**From:** Advanced Isotopes <nukedoses@gmail.com>  
**Sent:** Monday, June 15, 2015 12:22 PM  
**To:** Katanic, Janine  
**Subject:** Re: Evaluation of Iodine Room at Advanced Isotopes  
**Attachments:** NRC Inspection Response Revised (1).doc; Current I-131 Room Diagram.jpg; Anemometer.pdf; Biodex Hood.pdf

# **I-131 Room Hood** **Flow and Air Control**

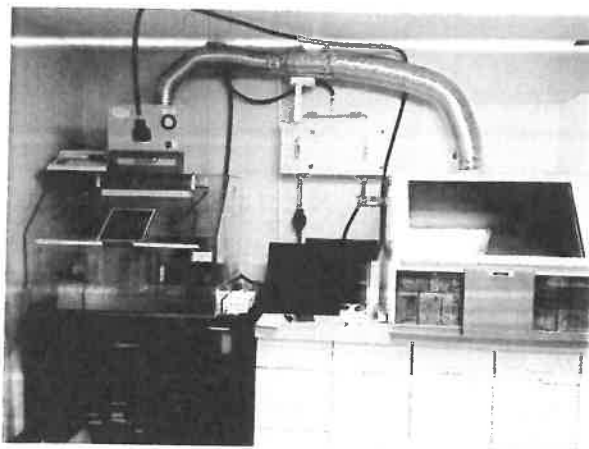
Thank you for your patience with us. I have triple-checked the math in this revision and you were absolutely correct that points "A" and "B" were reversed - I have changed the document to match the figure and tried to address every point of concern in your previous emails.

If you want to reevaluate your calculations, you can. Additionally, I was wondering if A and B were correct on your drawing or if they are reversed. The text in your writeup would lead me to believe that either the drawing or the writeup perhaps are not correct or maybe I am misunderstanding the setup.

All of these converge and pass through point “B” in the diagram, a pipe with a diameter of 4 inches (Area of pipe = 0.0872 ft<sup>2</sup>). On 3/2/15 a reading of 1230 linear feet/min, using Fisher Scientific Anemometer Model 1-241, serial #61603364 (calibration provided as an attachment to this document) was observed. The flow was calculated as follows:

A baffle within the charcoal filtration barrel that acted as a barrier to prevent the charcoal from blowing out was found to be obstructing outflow (at point “A”) and was cleared out on 5/29/15, and the airflow was adjusted to blow downward as it enters the charcoal to allow more surface area for contact on 6/13/15; an outflow reading taken at point “B” in the diagram on 6/14/15 was 2500 linear ft/min:
